Impedance WG report

Proposed recommendations for BGI

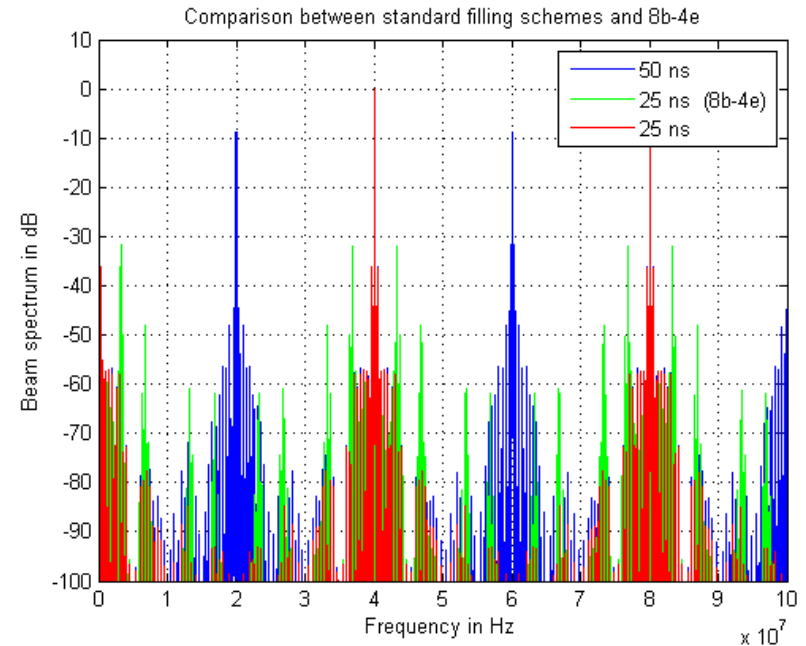
- Stability not believed to be an issue (even with bare metal plates) → need final simulations in transverse plane from Aaron
- Heating is large, with bare metal electrodes and coating → potential damage and outgassing
- Can we let a device which we know will heat to at least 250 C back in the LHC? → TE-VSC should check the outgassing at these high temperatures, statement by Giuseppe Bregliozi that it would not comply with the TE-VSC specifications

Proposed recommendation to BE-BI, presented to R. Jones and R. Veness (and agreed):

- Do not reinstall as is.
- Keep it away from the proton beam (e.g. installation only for ion run before LS2?).
- Work on a robust design to be installed after LS2. Several options, some of which could be combined:
 - Install only when there are ions in the machine
 - Screening of existing electrodes from proton beam with moveable or permanent shielding
 - Reduction of resonant modes by design change
 - Addition of active cooling
 - Damping of modes (coupler, all mode damper) for extraction of electromagnetic energy away to a well designed external system
